# Plan Commission Agenda

**Prepared for:** Plan Commission  
**Staff Contact:** Noah Wiedenfeld, Planning Director  
**Meeting:** Plan Commission - 06 Aug 2019  
**Subject:** Site Plan Application: New Richmond Professional Office Building

SHEET NO.  
**C1.4**

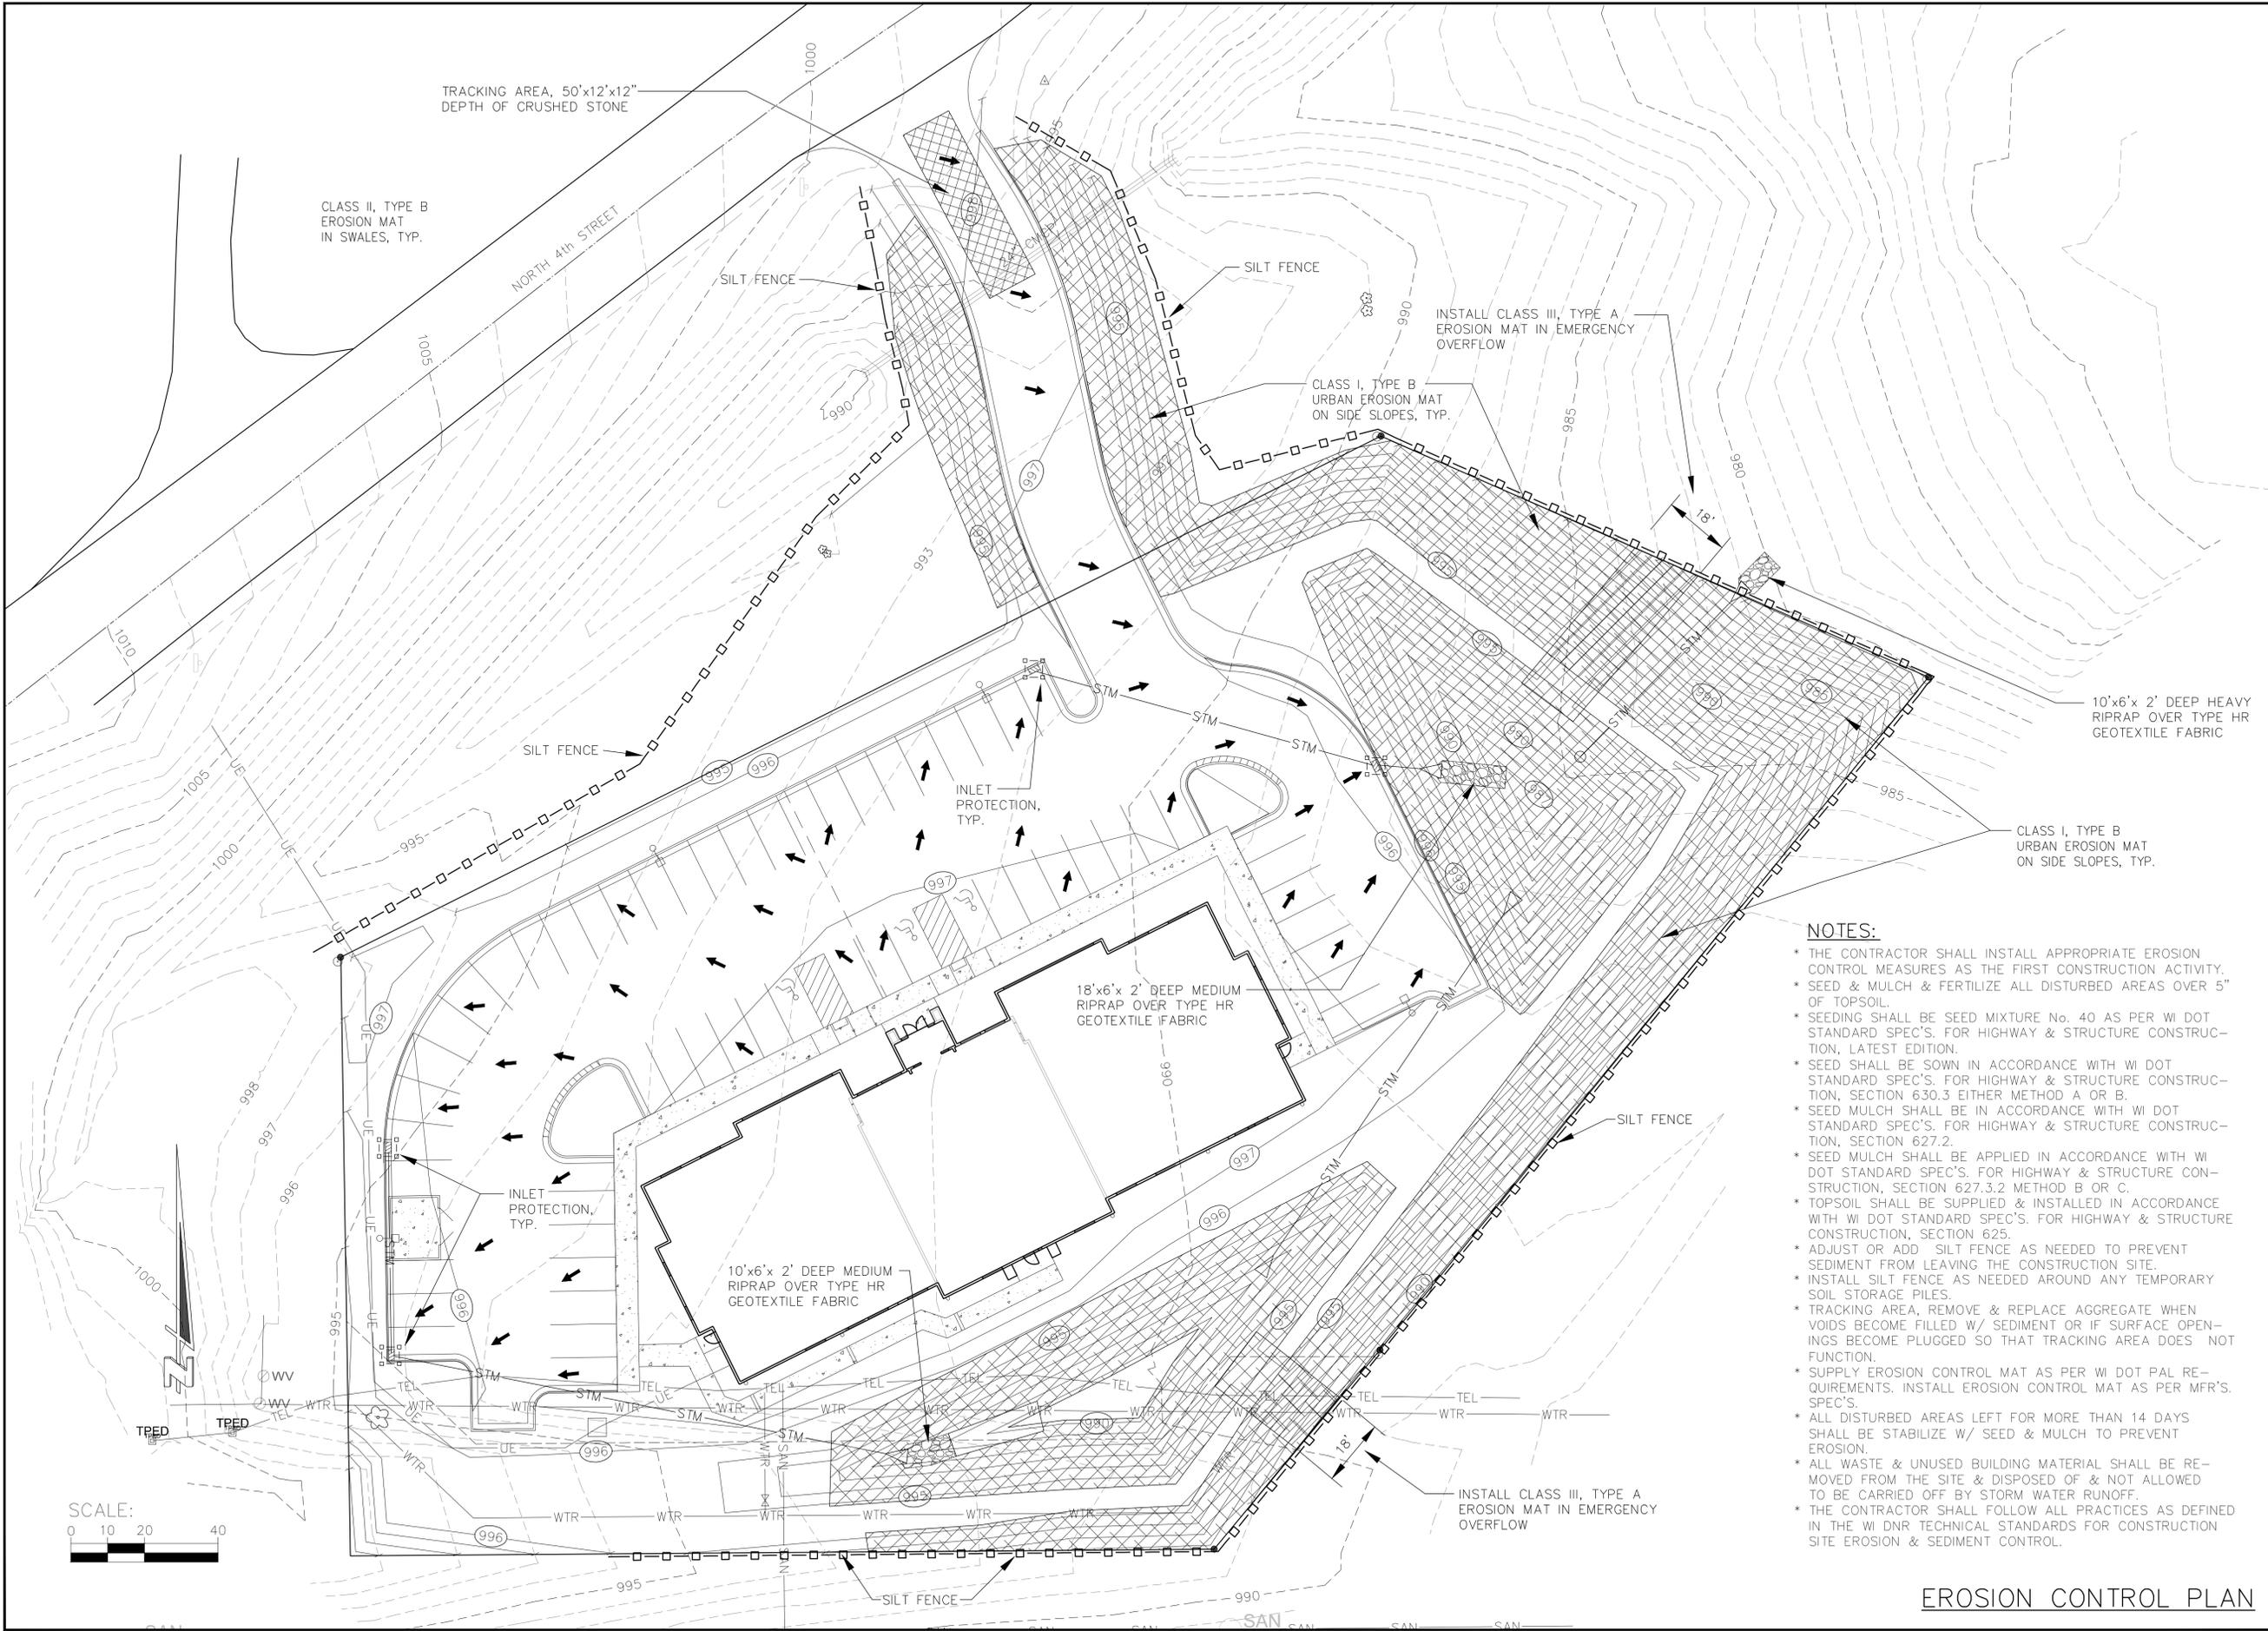
1. The report indicates that the west pond is a wet pond, but the plans do not reflect this. No safety shelf is provided. No wet pool liner is provided. The wet pool depth (2 feet) is not sufficient to prevent resuspension of sediment.

2. The report indicates that four catch basins have two foot sumps, but the plans do not reflect this.
3. The report indicates that the east pond provides an effective infiltration area of more than 2% of the total site area. The City's engineering consultant does not concur, since the effective infiltration area appears to be 108 square feet or just 0.1% of the 1.89 acre parcel.

5. The WinSLAMM modeling of the east pond has an error. The plans show the underdrain elevated slightly from the bottom of the engineered soils whereas the model shows it at the base.

6. The WinSLAMM modeling of the west pond has several errors. The plans show the outlet to be elevated two feet from the base of the pond whereas the model shows it elevated three feet. The plans show the emergency overflow to be elevated four feet from the base of the pond whereas the model shows it elevated five feet.

7. The plans show the emergency outlet from the east pond at nearly the highest point of the embankment. It's recommended that this be relocated to the northwest corner of the pond to reduce the chances of catastrophic embankment failure.

8. The plans show the outlet from Inlet #4 entering the east pond at an angle. I recommend making this outlet perpendicular to the slope.
9. The plans show the outlet from the west pond entering the east pond without outlet protection.

12. All grading, erosion control, and stormwater issues are subject to review and approval by the Director of Public Works.
13. The report indicates that the west pond is a wet pond, but the plans do not reflect this. No safety shelf is provided. No wet pool liner is provided. The wet pool depth (2 feet) is not sufficient to prevent resuspension of sediment.

14. The report indicates that four catch basins have two foot sumps, but the plans do not reflect this.
15. The report indicates that the east pond provides an effective infiltration area of more than 2% of the total site area. The City's engineering consultant does not concur, since the effective infiltration area appears to be 108 square feet or just 0.1% of the 1.89 acre parcel.

17. The WinSLAMM modeling of the east pond has an error. The plans show the underdrain elevated slightly from the bottom of the engineered soils whereas the model shows it at the base.

18. The WinSLAMM modeling of the west pond has several errors. The plans show the outlet to be elevated two feet from the base of the pond whereas the model shows it elevated three feet. The plans show the emergency overflow to be elevated four feet from the base of the pond whereas the model shows it elevated five feet.

19. The plans show the emergency outlet from the east pond at nearly the highest point of the embankment. It's recommended that this be relocated to the northwest corner of the pond to reduce the chances of catastrophic embankment failure.

20. The plans show the outlet from Inlet #4 entering the east pond at an angle. I recommend making this outlet perpendicular to the slope.
21. The plans show the outlet from the west pond entering the east pond without outlet protection.

SHEET NO.  
**C1.5**

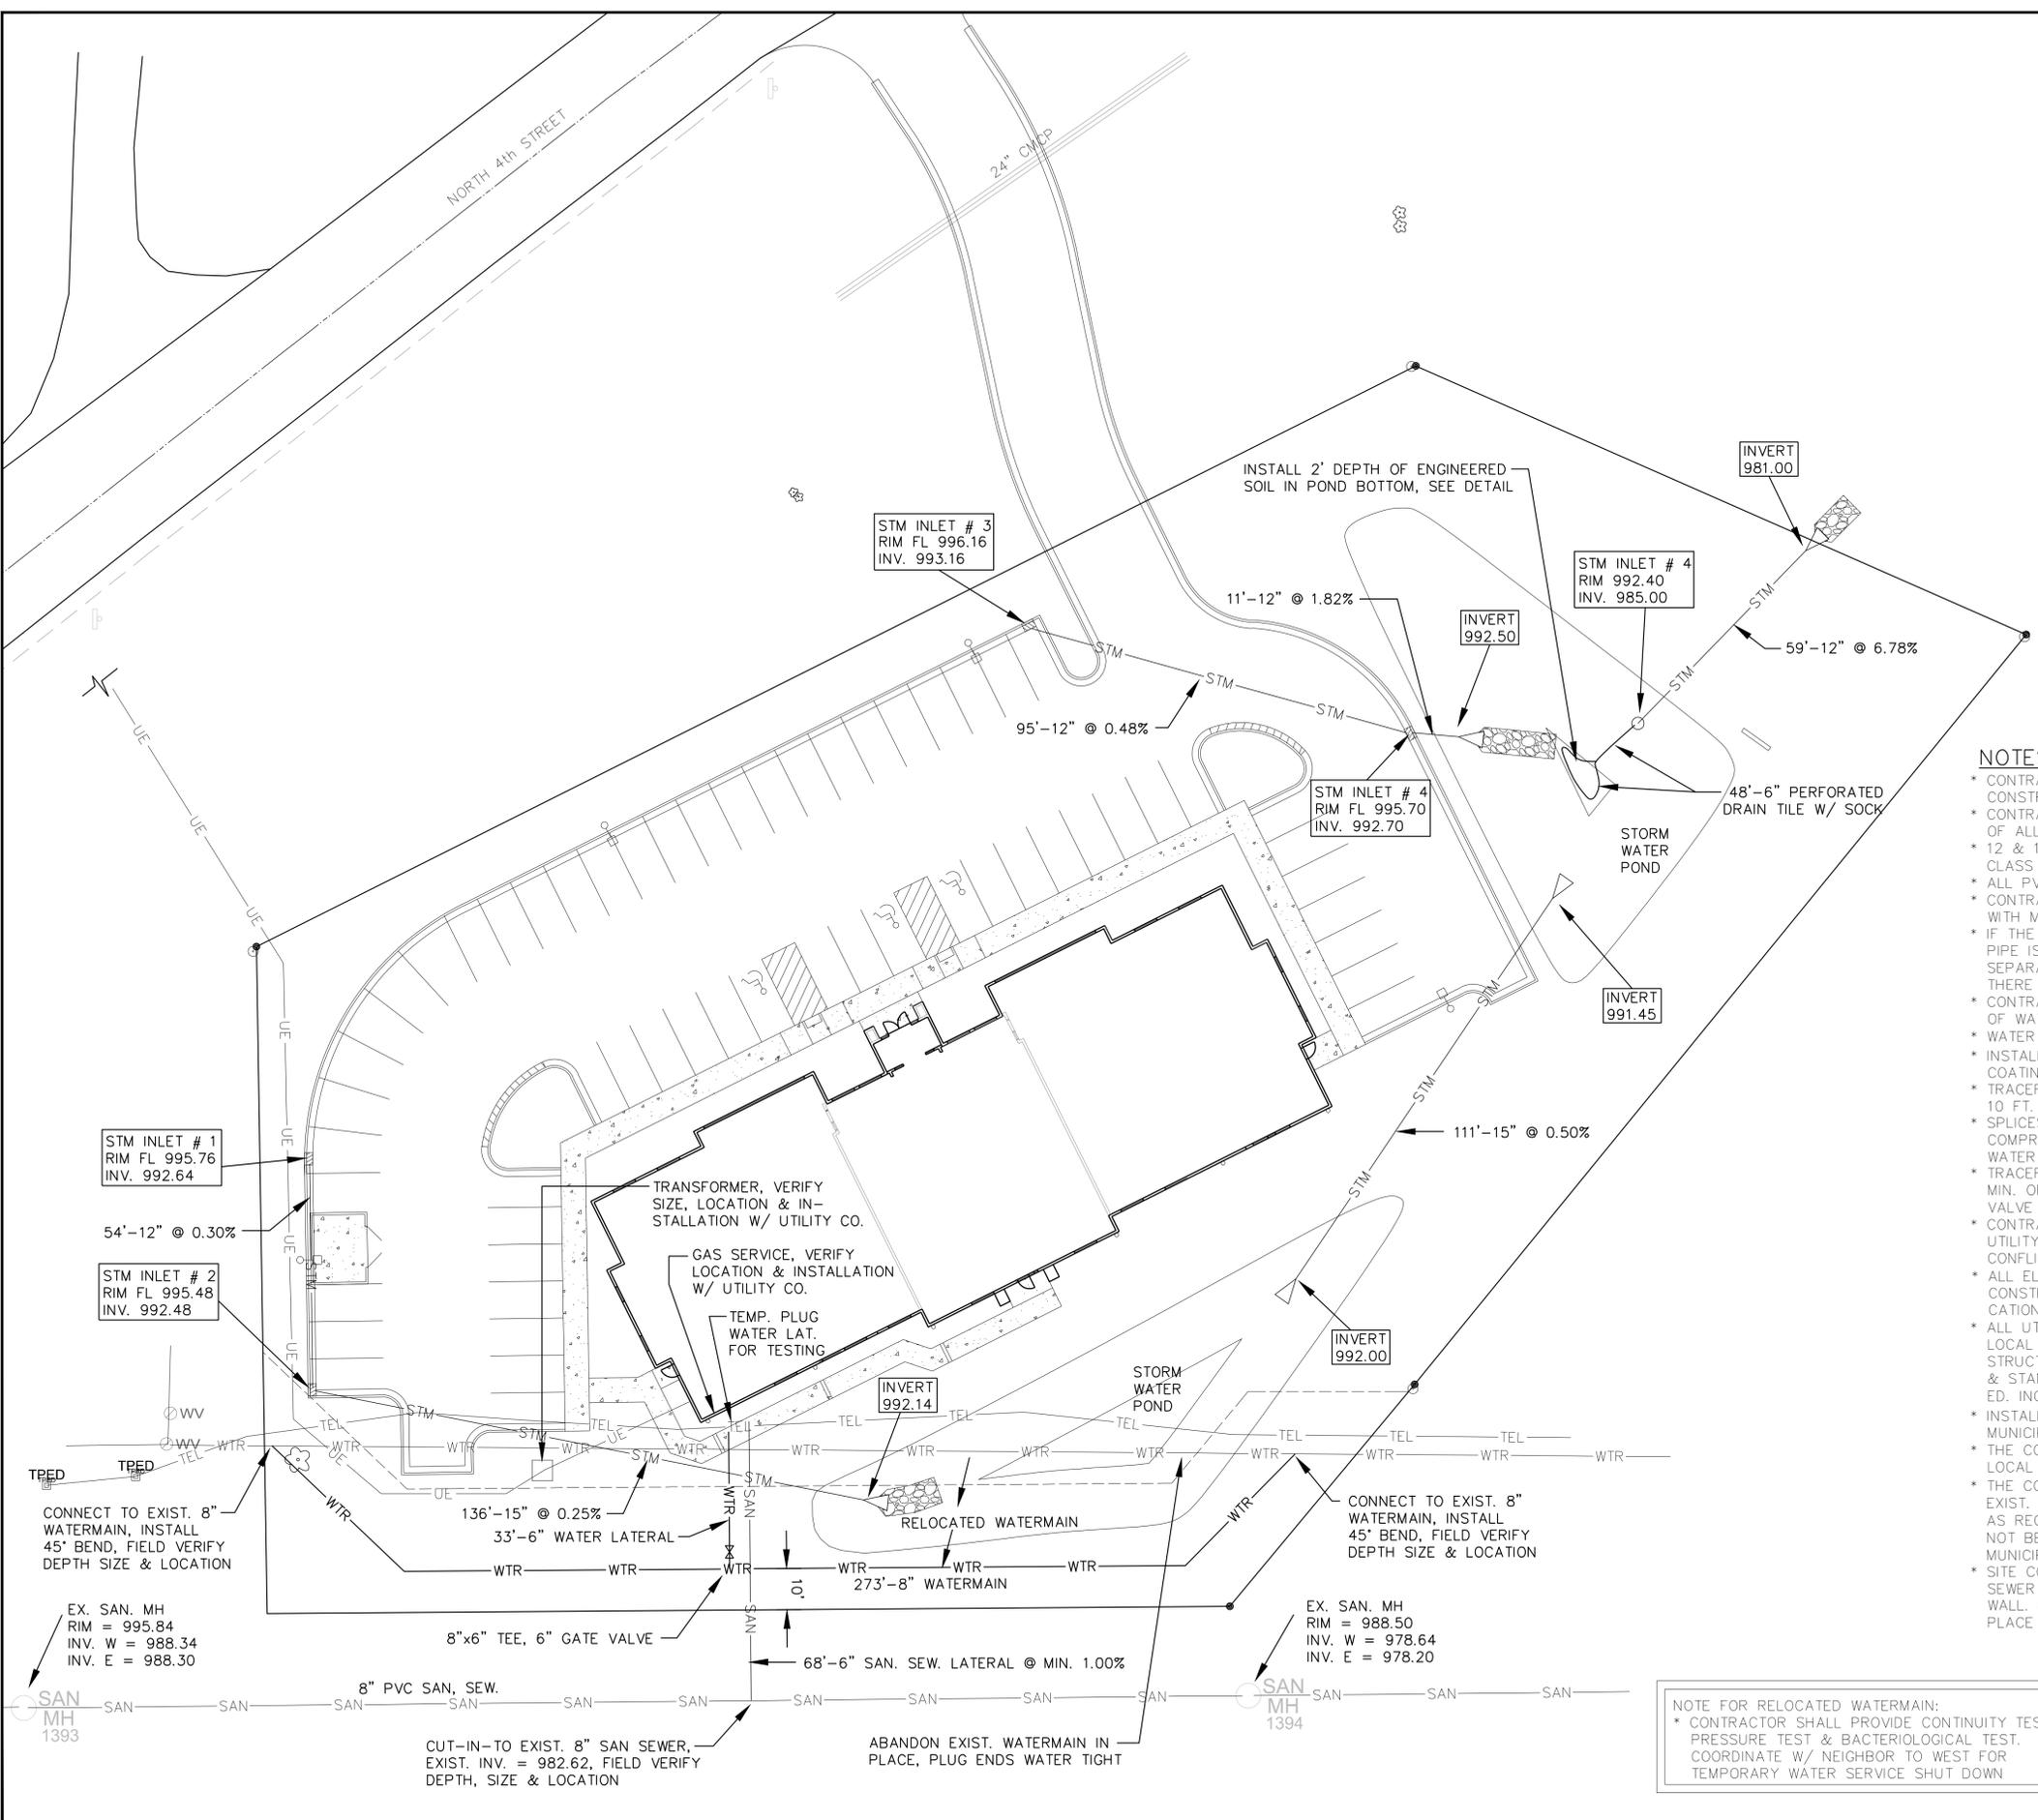
1. Sheet C1.5: Revise the plans to call out the watermain material as DIP Class 52, with a minimum 8' depth of bury.
2. Sheet C1.5: Call out two additional 45 degree bends on the relocated watermain.

3. Sheet C1.5: Call out joint restraint at all 45 degree bends, as well as the service tee, and provide a detail.
4. Sheet C1.5: Add a hydrant near the western connection of the relocated watermain to allow for flushing and adequate fire protection.

5. Sheet C1.5: The City suggests that the water service lateral be installed to a point underneath the building footprint, a restrained 90 degree joint installed, and rodding installed with the pipe vertically through the floor for connection to the internal plumbing system.

6. Sheet C1.5: It is the City's opinion that new gate valves will be needed on either end of the relocated watermain in order to accomplish the bacteriological and pressure testing of the new watermain. If the valves are not to be installed, the designer needs to submit a plan detailing the proposed procedure for performing these tests, and how to address a failed pressure test.

4. Sheet C1.5: Revise the plans to call out the watermain material as DIP Class 52, with a minimum 8' depth of bury.
5. Sheet C1.5: Call out two additional 45 degree bends on the relocated watermain.

6. Sheet C1.5: Call out joint restraint at all 45 degree bends, as well as the service tee, and provide a detail.
7. Sheet C1.5: Add a hydrant near the western connection of the relocated watermain to allow for flushing and adequate fire protection.

8. Sheet C1.5: The City suggests that the water service lateral be installed to a point underneath the building footprint, a restrained 90 degree joint installed, and rodding installed with the pipe vertically through the floor for connection to the internal plumbing system.

9. Sheet C1.5: It is the City's opinion that new gate valves will be needed on either end of the relocated watermain in order to accomplish the bacteriological and pressure testing of the new watermain. If the valves are not to be installed, the designer needs to submit a plan detailing the proposed procedure for performing these tests, and how to address a failed pressure test.
